# A HUBBARD
## BUILDER & DESIGNER

Re: Proposed Erection of a garden room at The Forge, 41, Town Street, Duffield, Derbyshire, DE56 4GD for Mr. & Mrs. J. Whiting
Your reference HEATHW-AVA/2020/0878

Appendix II. Tree Location Plan.

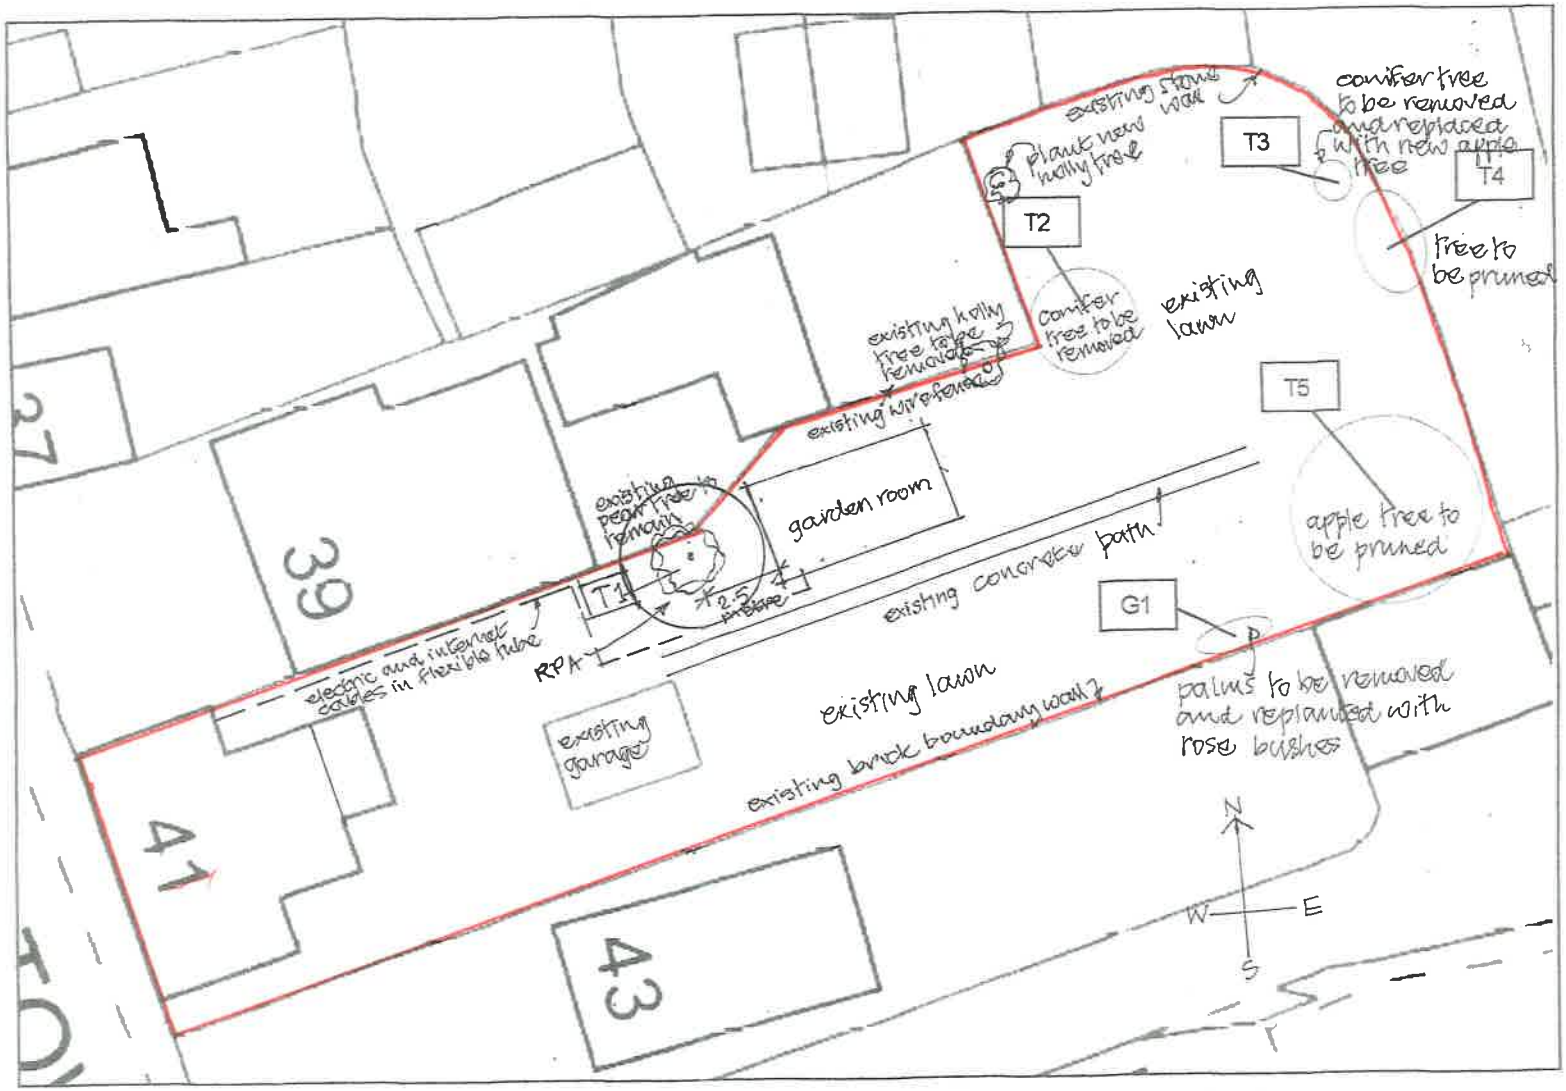
I enclose herewith an amended Block Plan showing the Tree Protection Area circled, and at a larger scale a copy of the Plan provided by our tree specialist showing the RPA for the pear tree to be retained. We are assuming the RPA. only applies to the work adjacent to the Pear tree, as the plan indicates the removal of the adjacent Holly tree as this is choking with ivy, and also the removal of the larger conifer tree.

As shown in our tree specialist report root protection at surface level can be provided by geotextile matting laid on the ground with scaffold boarding on top in the area of the Pear Tree and around the Garden room if required. We feel that as all the work to install the pile foundations for the Garden Room are all to be dug by hand with care taken on any roots found as described in the report, that the scaffold panel protection will not be required, but if you insist on this, it can be erected.

BLOCK PLAN
THE FORGE
41 TOWN STREET
DUFFIELD
DERBYSHIRE
DE56 4GD
SCALE 1:500
for MR & MRS. J WHITING

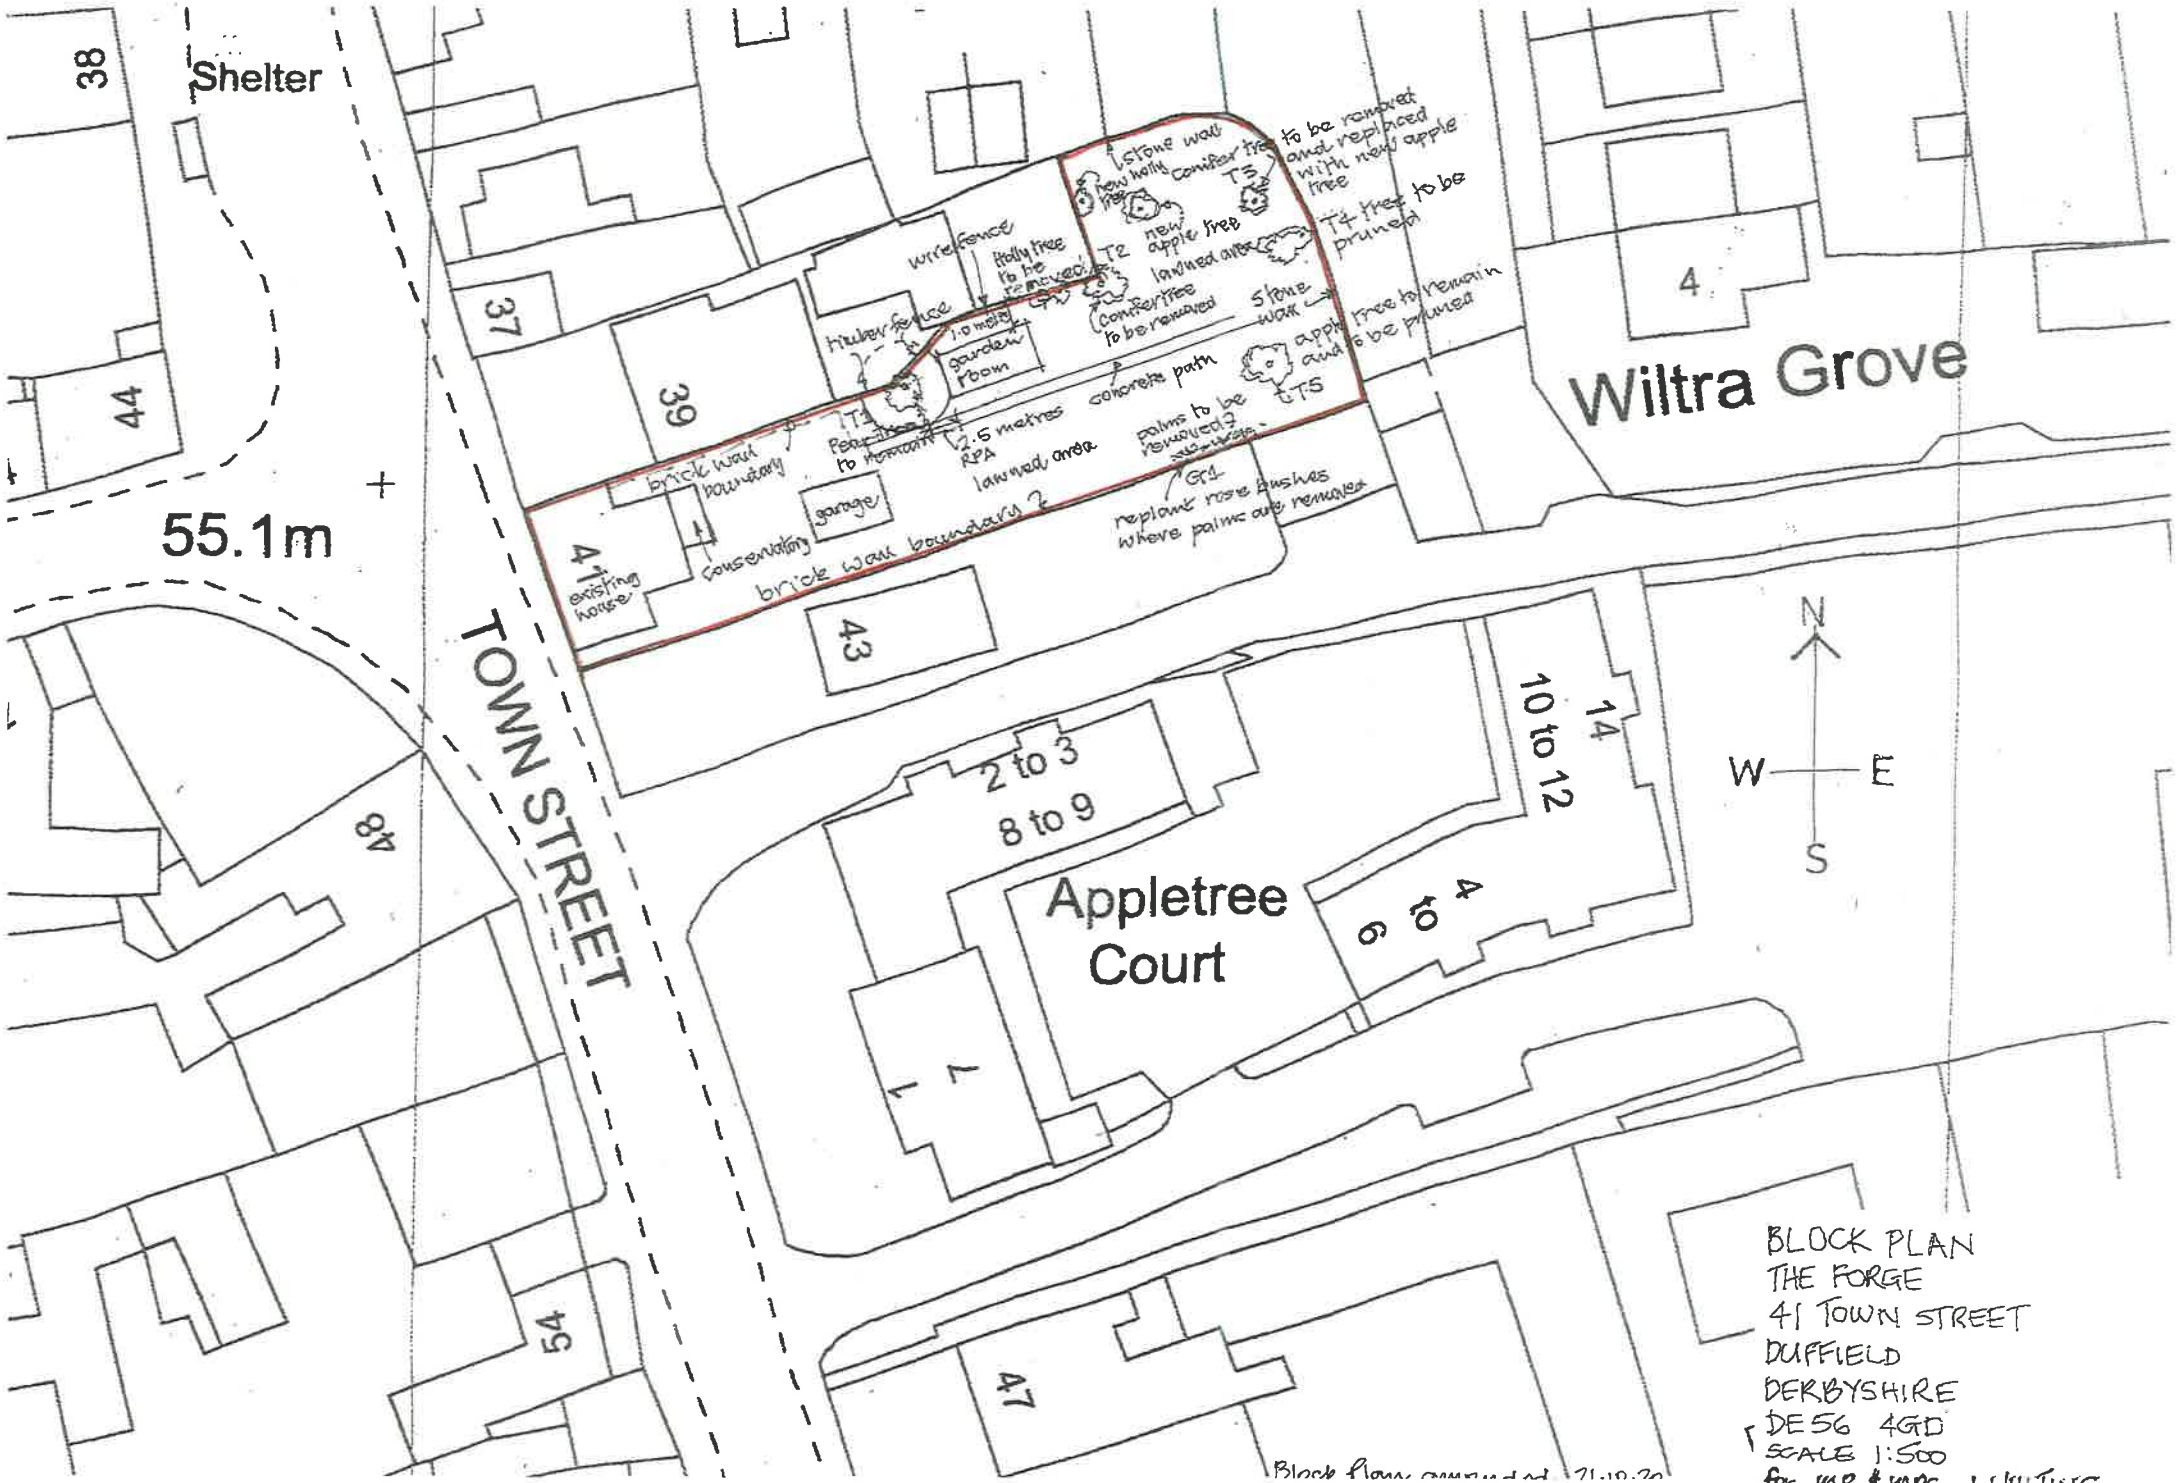
PLAN RELATING TO
41, TOWN STREET · DUFFIELD · DERBYSHIRE · DE56 4GD
SHOWING RPA AREA TO PEAR TREE
AND INDICATING THE HOLLY TREE TO BE REMOVED
AND A NEW HOLLY TREE PLANTED IN REAR GARDEN

Block plan amended 21.12.20
